UNITED STATES PATENT AND TRADEMARK OFFICE

APPLICATION NO.	FILING DATE	FIRST NAMED INVENTOR	ATTORNEY DOCKET NO.	CONFIRMATION NO.
10/500,248	06/25/2004	Michel Berdoyes	BDL-461XX	8913
207	7590	12/10/2004		
WEINGARTEN, SCHURGIN, GAGNEBIN & LEOVICI LLP TEN POST OFFICE SQUARE BOSTON, MA 02109				
			EXAMINER RODRIGUEZ, WILLIAM H	
			ART UNIT 3746	PAPER NUMBER

Office Action Summary

DETAILED ACTION

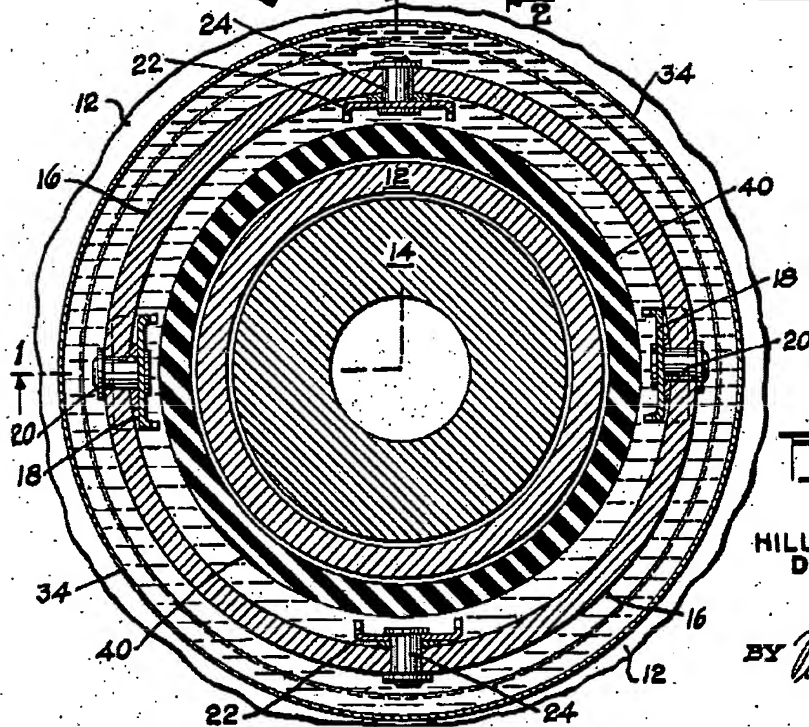
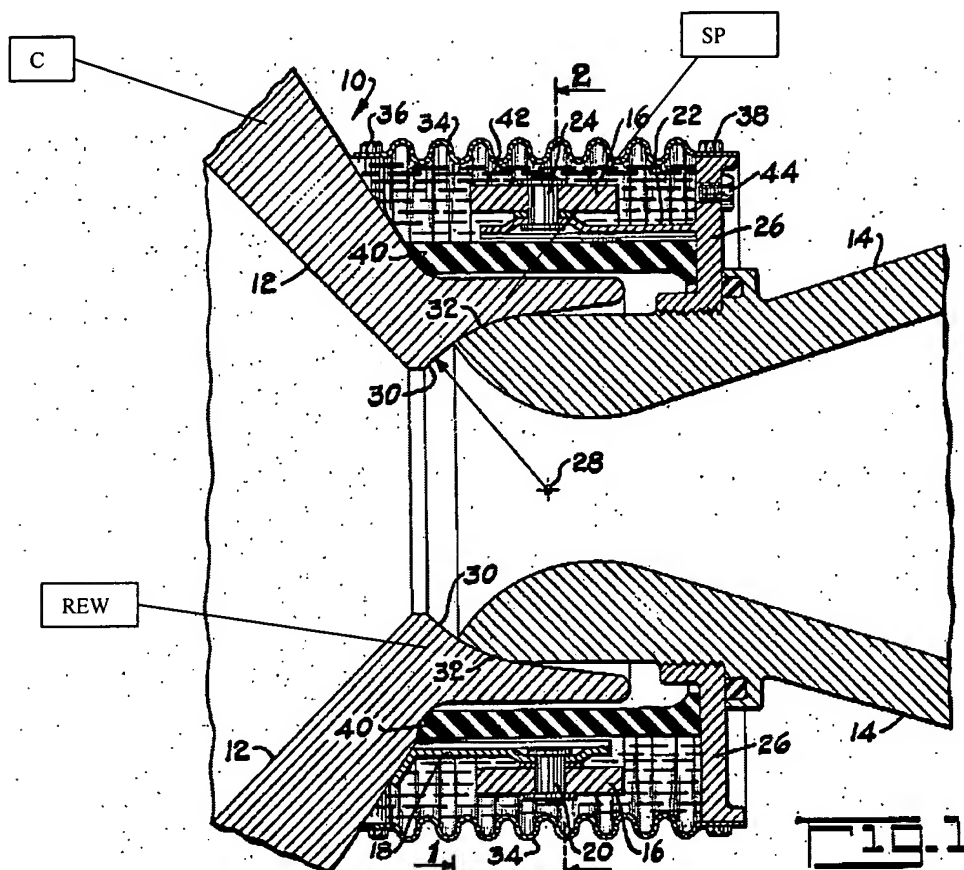
With respect to claim 1, **Barrett** teaches a steerable nozzle for rocket engine comprising: casing (C) surrounding a combustion chamber and having rear end wall (REW); a nozzle comprising moving diverging portion (14) and a static portion (SP) secured to the rear end wall; a jointed link device connecting the moving diverging portion of the nozzle to the static portion, the moving diverging portion and the static portion being in mutual contact via respective spherical surfaces (30, 32); and an actuator device (not shown but mentioned, column 1 line 68-column 2 line 2) acting on the moving diverging portion of the nozzle to enable the direction of the thrust vector of the engine to be varied by modifying the orientation of the nozzle with the spherical surfaces sliding one on the other, resilient return means (34) are interposed between the moving diverging portion (14) of the nozzle and the static portion (SP), said resilient return means acting on the moving diverging portion to urge it towards the static portion so as to keep the spherical surfaces (30, 32) in mutual contact for any desired orientation of the nozzle. See particularly **Figures 1, 2** of Barrett.

Note: the jointed link device or cardan mount can be comprised of the following elements: 22, 26, 36, 18, 20, 24, 16, 34, 40, 38, 44.

With respect to claim 2, **Barrett** teaches that the link device is a cardan mount comprising a ring (16), two first link arms (22) connecting the moving diverging portion (14) of the nozzle to the ring via two first hinges (24), and two second link arms (18) connecting the ring to the rear end wall of the casing via two second hinges (20), the resilient return means (34) are integrated in link arms. See particularly **Figures 1, 2** of Barrett.

With respect to claim 3, **Barrett** teaches that resilient return means 34 are integrated in the first link arms (22). See particularly **Figures 1, 2** of Barrett.

With respect to claim 5, **Barrett** teaches that the resilient return means (34 or 16 or 40) are constituted at least in part by an elastically deformable part of the link device which is elastically deformed on assembly. See particularly **Figures 1, 2** of Barrett.

With respect to claim 6, **Barrett** teaches that the resilient return means are constituted at least in part by the ring (16) of the cardan mount which is elastically deformable and is elastically deformed on assembly. See particularly **Figures 1, 2** of Barrett.

With respect to claim 12, **Barrett** teaches a steerable nozzle for a rocket engine comprising: a casing C surrounding a combustion chamber and having a rear end wall REW; a nozzle comprising a moving diverging portion 14 and a static portion SP secured to the rear end wall; a cardan mount connecting the moving diverging portion of the nozzle to the static portion, the moving diverging portion and the static portion being in mutual contact via respective spherical surfaces 30, 32, the cardan mount comprising a ring 16, two first link arms 22 connecting the moving diverging portion of the nozzle to the ring 16 via two first hinges 24, and two second link arms 18 connecting the ring 16 to the rear end wall of the casing via two second hinges 20; an actuator device (not shown but mentioned, column 1 line 68- column 2 line 2) acting on the moving diverging portion 14 of the nozzle to enable the direction of the thrust vector of the engine to be varied by modifying the orientation of the nozzle with the spherical surfaces sliding one on the other; and resilient return means 34 or 40 integrated in link arms of the cardan mount and acting on the moving diverging portion to urge it towards the static portion so as to keep the spherical surfaces in mutual contact for any desired orientation of the nozzle. See particularly **Figures 1, 2** of Barrett.

With respect to claim 13, **Barrett** teaches a steerable nozzle for a rocket engine comprising: a casing C surrounding a combustion chamber and having a rear end wall REW; a nozzle comprising a moving diverging portion 14 and a static portion SP secured to the rear end wall; a cardan mount connecting the moving diverging portion of the nozzle to the static portion, the moving diverging portion and the static portion being in mutual contact via respective spherical surfaces 30, 32; and an actuator device (not shown but mentioned, column 1 line 68-column 2 line 2) acting on the moving diverging portion the nozzle to enable the direction of the thrust vector of the engine to be varied by modifying the orientation of the nozzle with the spherical surfaces sliding one on the other; the ring 16 or 40 of the cardan mount being elastically deformed on assembly to act on the moving diverging portion to urge it towards the static portion so as to keep the spherical surfaces in mutual contact for any desired orientation of the nozzle. See particularly **Figures 1, 2** of Barrett.

FIG. 2

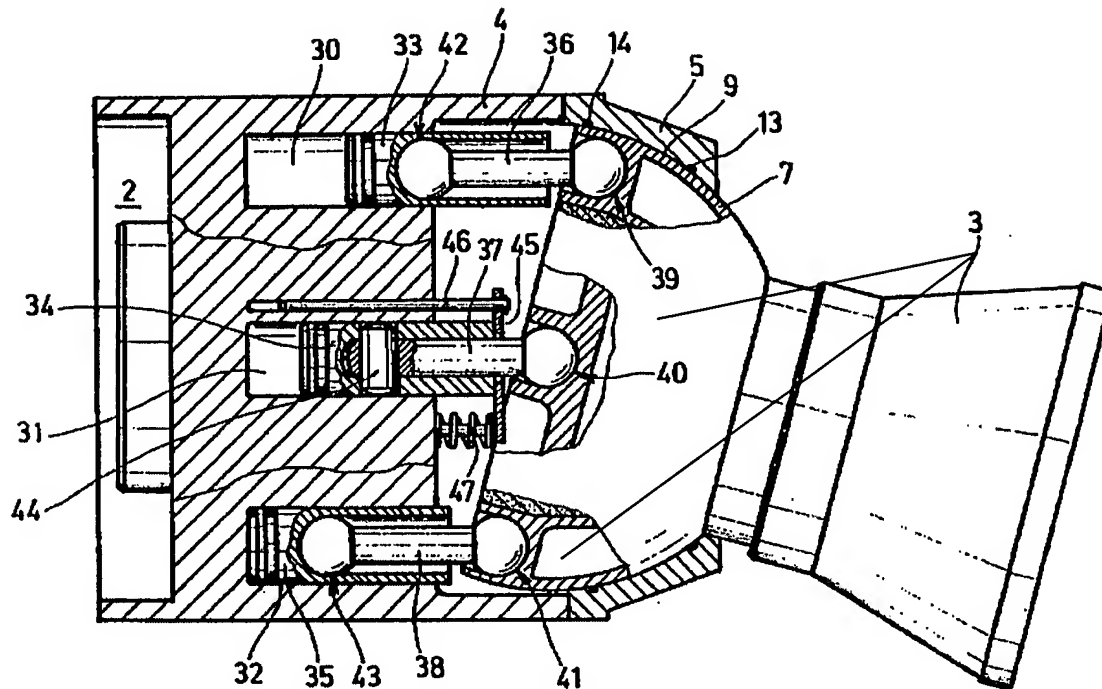
With respect to claim 1, **Rossmannith** teaches a steerable nozzle for rocket engine comprising: casing (4) surrounding a combustion chamber and having rear end wall; a nozzle comprising moving diverging portion (3) and a static portion (5) secured to the rear end wall; a jointed link device (6, see Figure 1) connecting the moving diverging portion of the nozzle to the static portion, the moving diverging portion and the static portion being in mutual contact via respective spherical surfaces (7, 9); and an actuator device (36-38) acting on the moving diverging portion of the nozzle to enable the direction of the thrust vector of the engine to be varied by modifying the orientation of the nozzle with the spherical surfaces sliding one on the other, resilient return means (47) are interposed between the moving diverging portion (3) of the

nozzle and the static portion (5), said resilient return means acting on the moving diverging portion to urge it towards the static portion so as to keep the spherical surfaces (30, 32) in mutual contact for any desired orientation of the nozzle. See particularly **Figures 1, 2** of Rossmanith.

With respect to claim 4, **Rossmannith** teaches that the resilient return means 47 comprise pre-stressed springs. See particularly **Figure 2** of Rossmanith
